OUR REF: JOB NO. 21092 – S4.55(8)

28 May 2024

**RE: SECTION 4.55(8) MODIFICATION FOR DEVELOPMENT APPLICATION (DA NO. 617/2021/B)
NOS. 33-35 CHURCH STREET, RANDWICK**

Figure 2: Approved and Proposed Basement Floor Plan

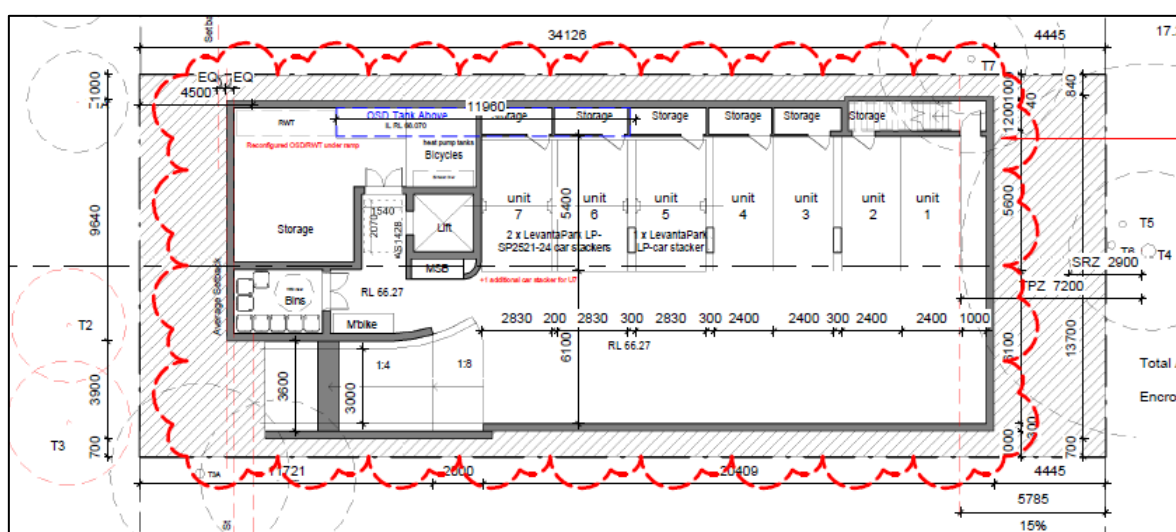
- Reconfiguration of the OSD/RWT system under ramp;
- Introduction of one extra car stacker for Unit 7; and
- Basement extension to the west (rear) by 140mm to accommodate the proposed car stacker.

Figure 3: Approved and Proposed Ground Floor Plan

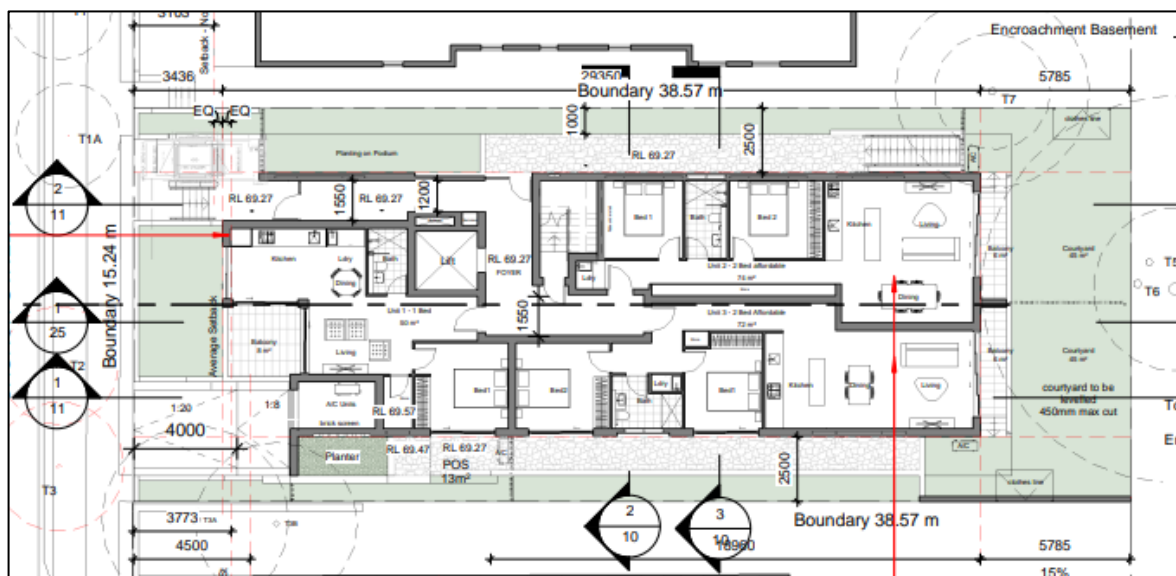
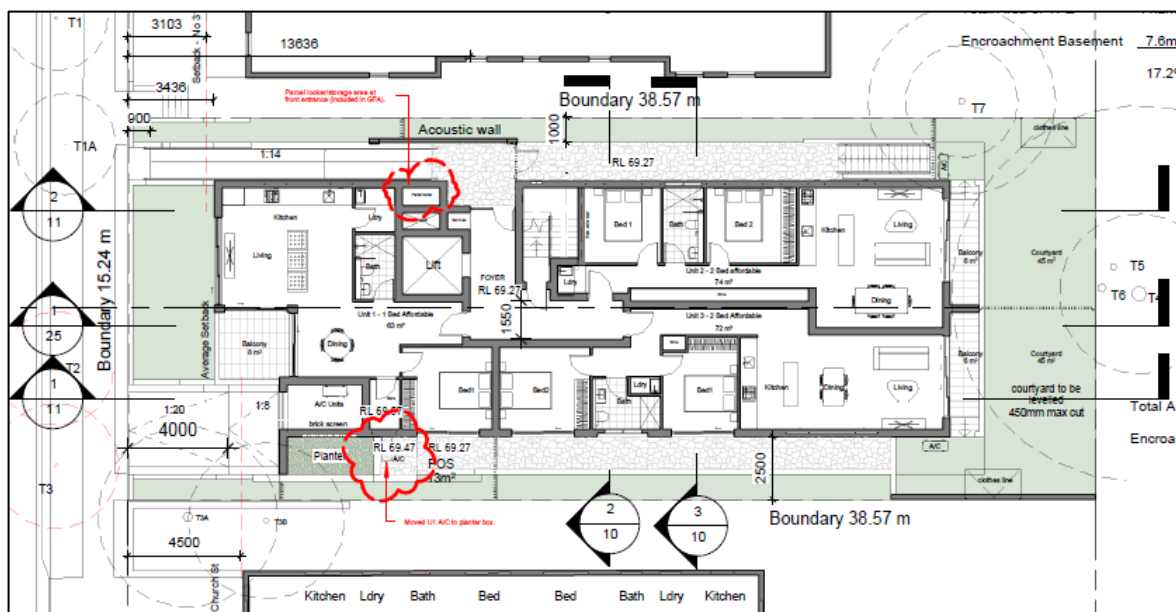
- Removal of the platform lift on the north-western corner;
- Replace the front entrance with a new accessible side pathway along the northern boundary, with a ramp of 1:14;
- Accommodation of a new acoustic screen wall to the ground floor entry, whose acoustic performance meets or exceeds the previously approved entrance;
- Internal layout refinement of Unit 1 (extended from 50m² to 63m²);
- Provision of the parcel locker/storage at the entrance; and
- Relocation of Unit 1's A/C condenser unit to the planter box (adjacent to Bedroom 1); and
- Provision of a new awning over common entrance in line with acoustic wall for weather protection.

Figure 6: Approved and Proposed Level 3 Plan

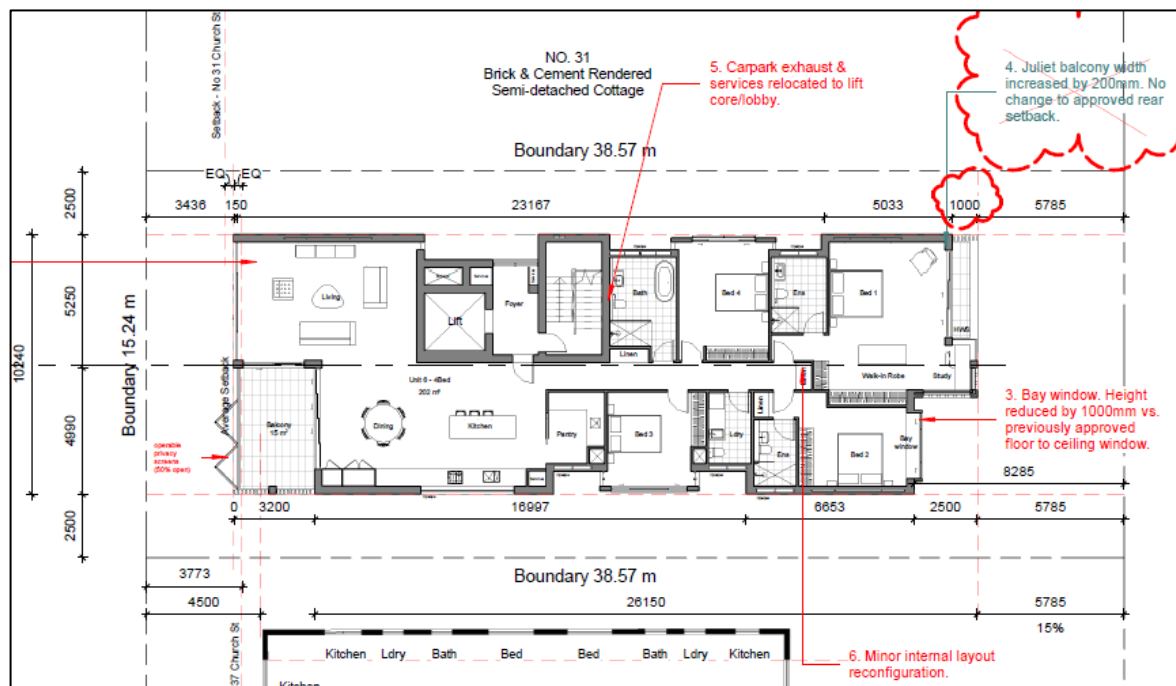
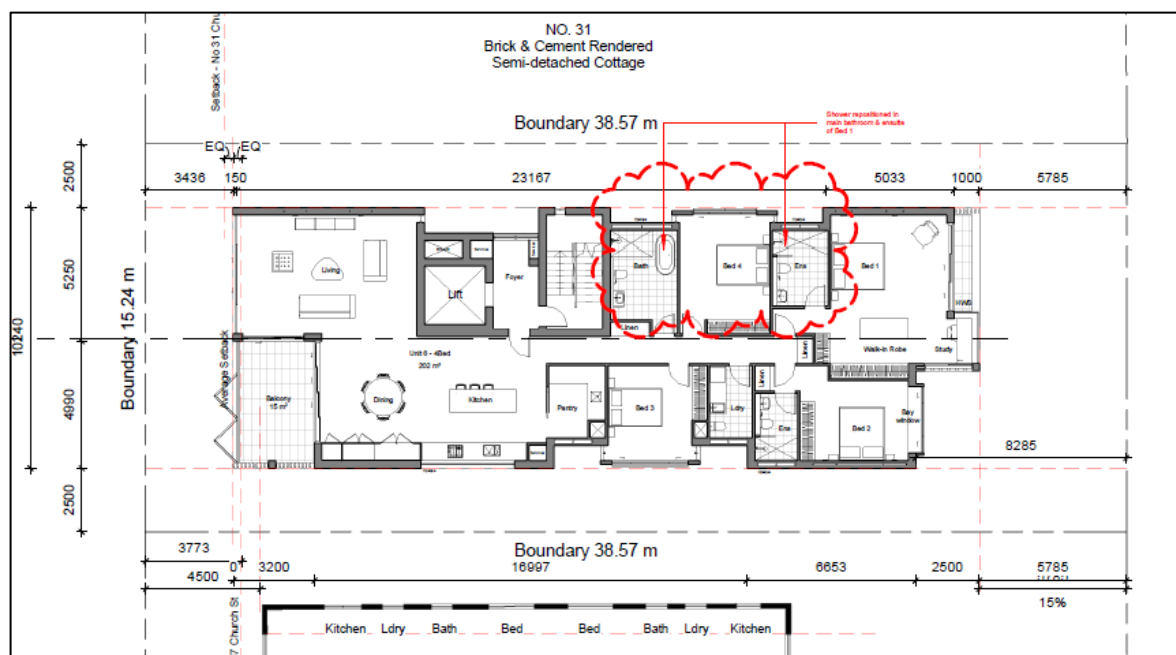
- Expansion of Unit 7 from 2BR to 3BR unit. Detailed works include extend the approved front glazing line of Unit 7 to the west by 1.74 metres, with a refined front balcony; extend the rear glazing line to the east by 1.74 metres, with a new rear balcony; a new north-facing dormer to Bedroom 2 & 3; refinement of the south-facing dormer to the dining and kitchen area and one new south-facing window to the proposed laundry.

Figure 5: Approved and Proposed Level 2 Plan

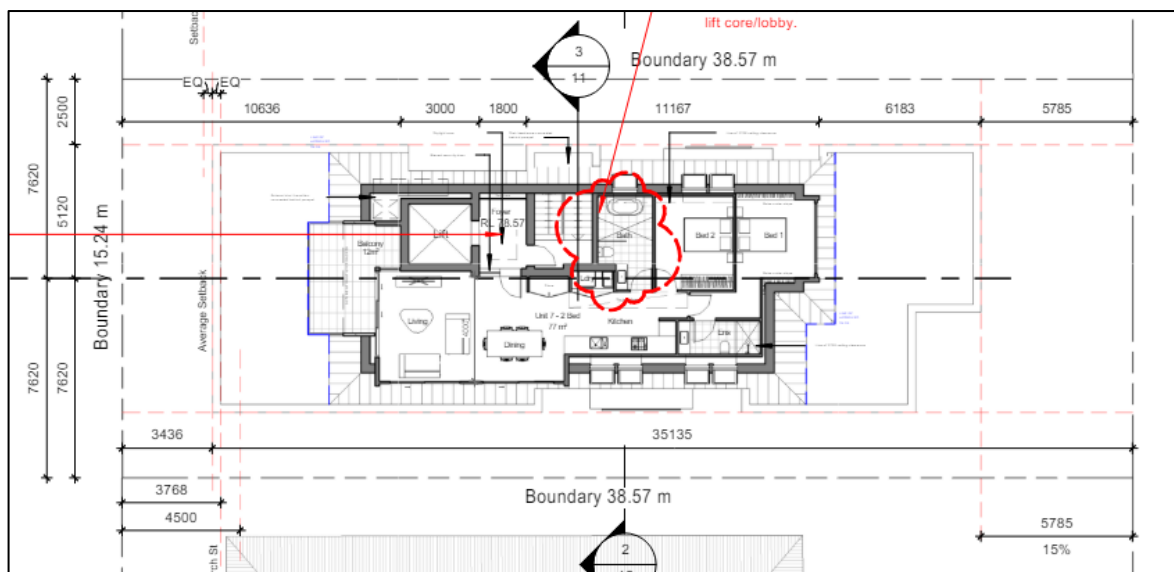
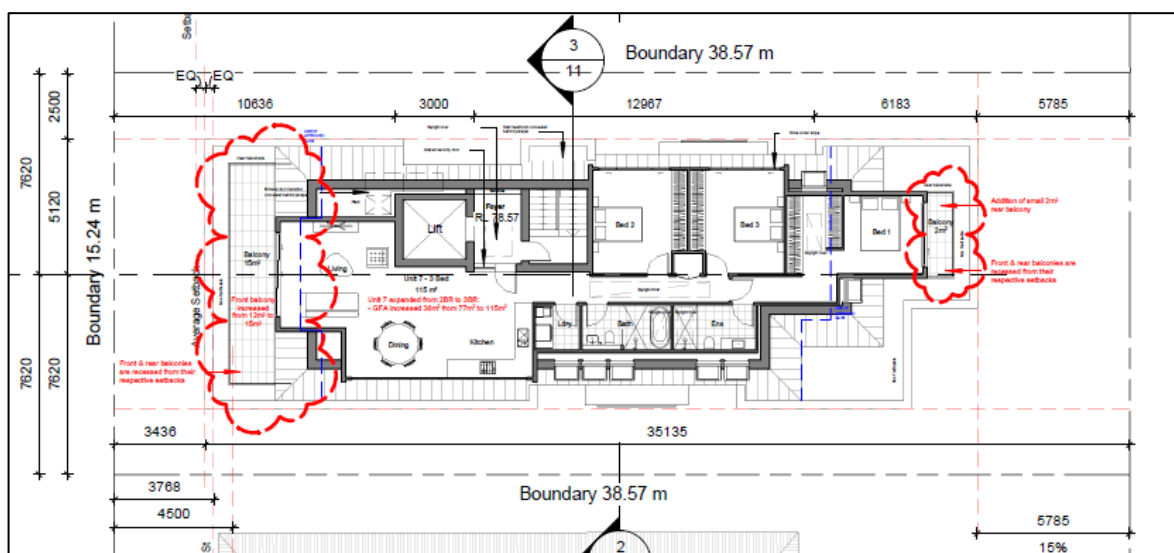
- Reposition of showers in the main bathroom and Bedroom 1's ensuite.

Figure 7: Approved and Proposed Roof Plan

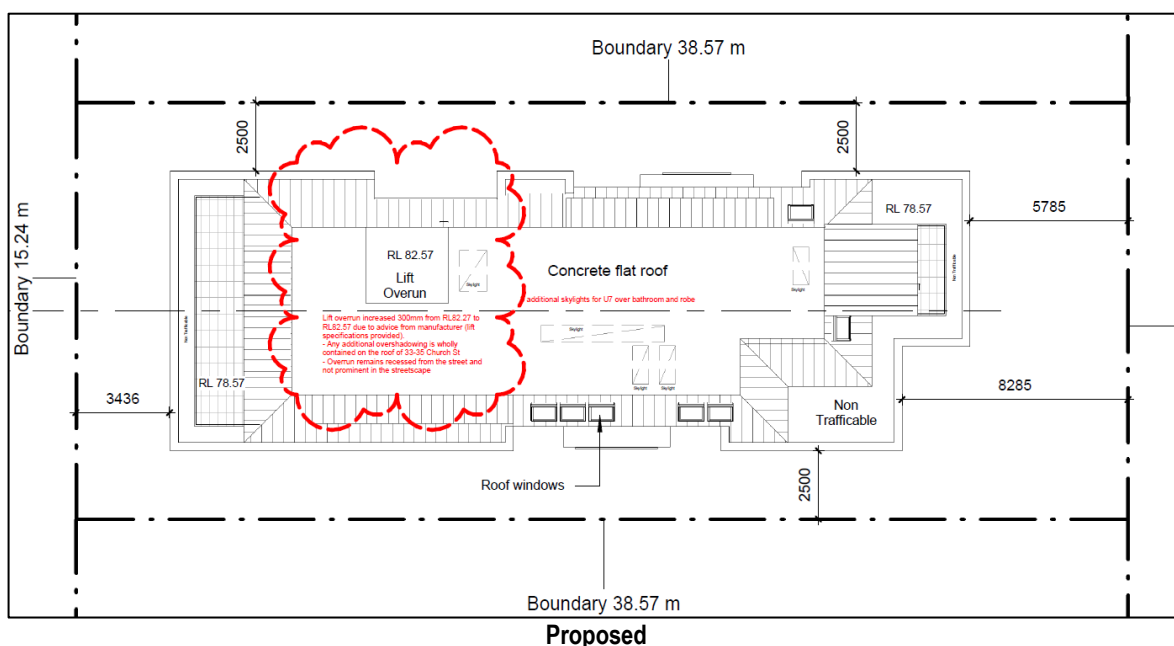
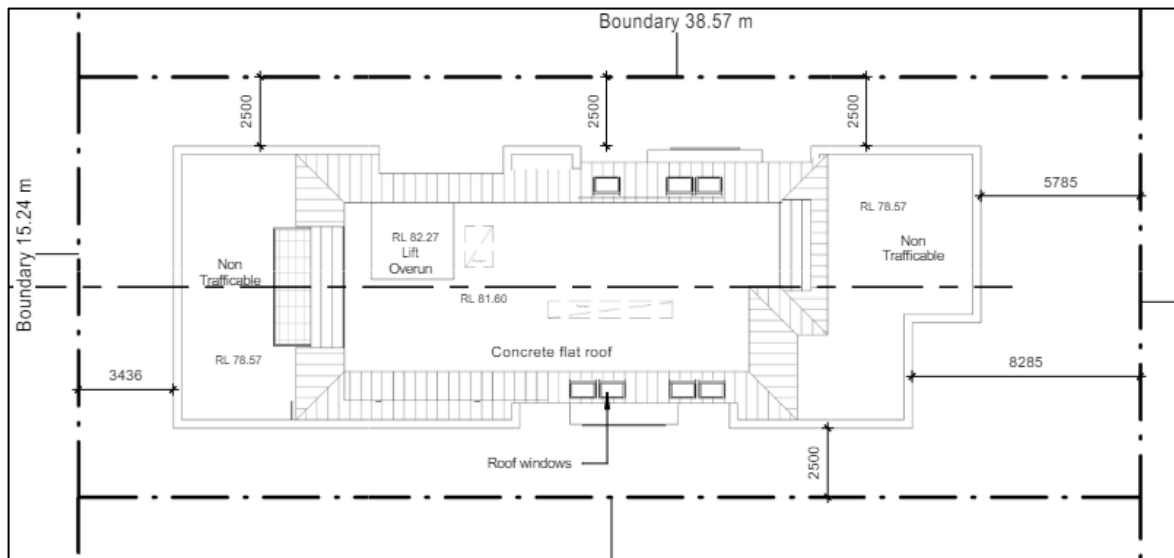
- Height increase of the lift overrun by 300mm (from RL 82.27 to RL 82.57), due to the minimum headroom requirements for passenger lifts (a supporting letter has been prepared by Schindler Lifts Australia Pty Ltd, separately submitted); the amended overrun remains recessed from the street and not prominent in the streetscape; and
- Three additional skylights over Unit 7's bathroom and robes.

Figure 9: Approved and Proposed North Elevation

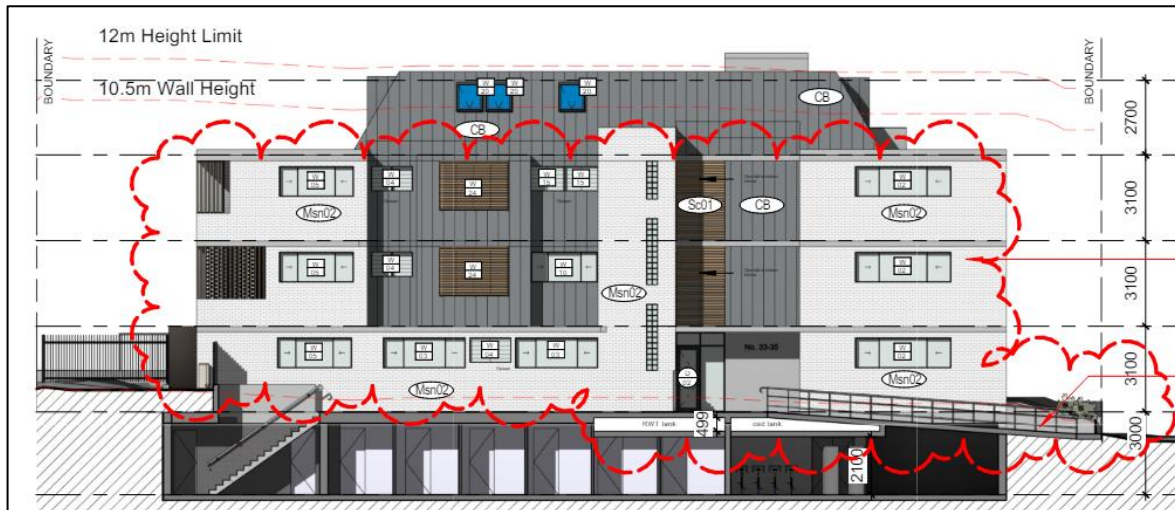
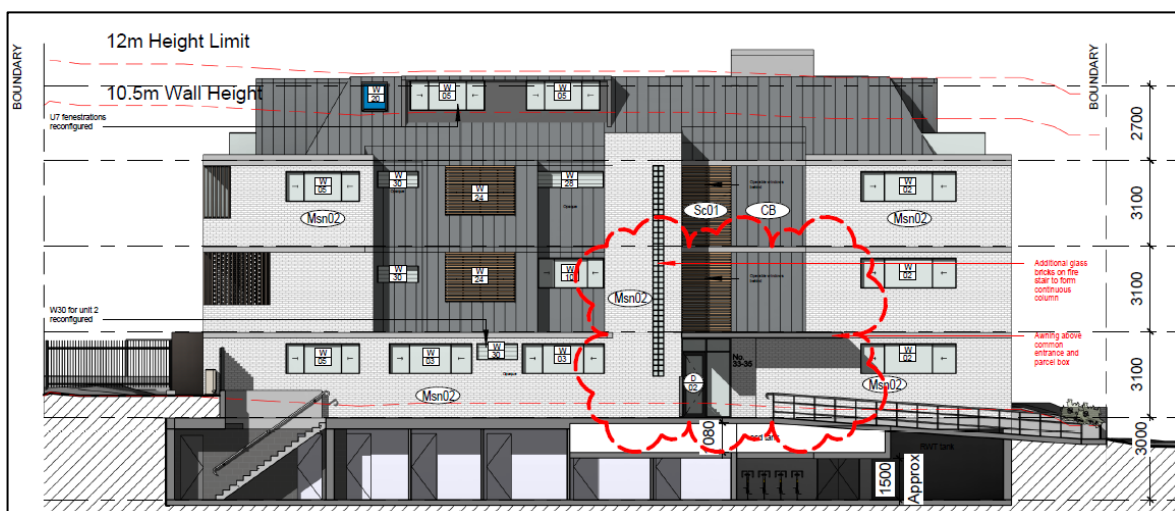
- A new dormer with new windows to Unit 7's Bedroom 2 and 3;
- Additional glass bricks on fire stair to form continuous column; and
- A new awning above common entrance and parcel box.

Figure 11: Shadow Diagrams on 21st June

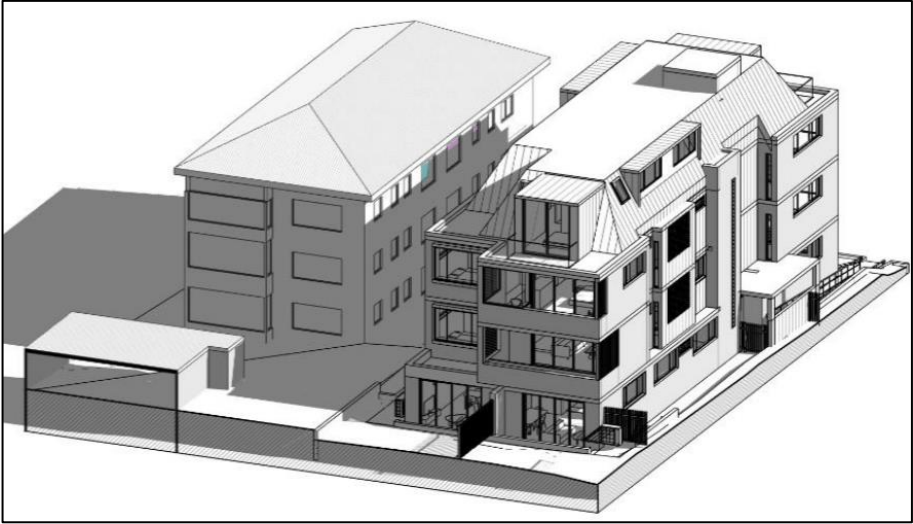
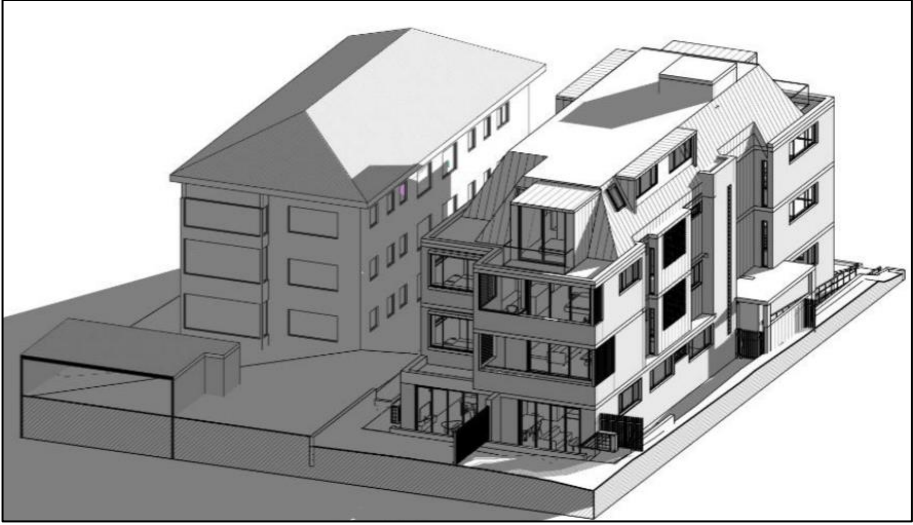
At 8:00 am, the proposed modification will cast additional shadows over the roof and minor portion of the north elevation wall at No. 37 Church Street, with no impact on the neighbouring properties' north-facing windows or private open space.

At 9:00 am, the proposed rear extension on Level 3 will result in minor additional overshadowing to the two east-end north-facing windows (Level 2) at No. 37 Church Street (pink area in **Figure 11**).

At 12 noon, the proposed front extension on Level 3 will result in additional shadow to the upper portion of two north-facing windows (Level 2) at No. 37 Church Street (pink area in **Figure 11**). However, due to the proposed minor reduction to the south-facing dormer on Level 3, another north-facing window (Level 2) of No. 27 Church Street will gain direct sunlight (green area in **Figure 11**). In addition, the portion of windows affected by the proposed modification is smaller than the portion of windows that regained sunlight, which is an improvement of amenity when compared to the previous approval.

At 4:00 pm, additional shadow will occur to the roofs of Nos. 20 and 22 Cook Street and minor impact to one north-facing window (Level 2) at No. 37 Church Street.
